S4.55(1A) MODIFICATION REPORT

Doncaster Ave, Kensington

Prepared for
COR PARTNERS
7 December 2021

Figure 1 Approved and proposed cluster rooms

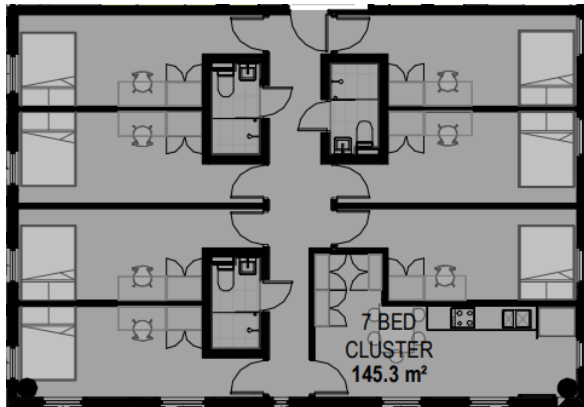
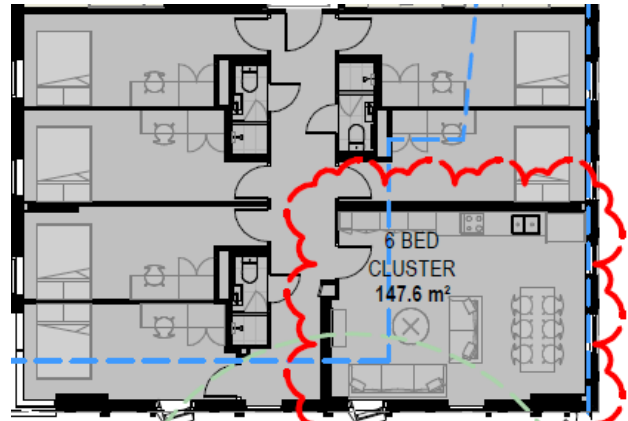
- **Redesign of the five 7 bed clusters into 6 bed clusters**

It is proposed to reconfigure the five approved seven bed clusters into six bed clusters. The proposed modification to the design will provide a larger common area within the clusters as shown in **Figure 1**.
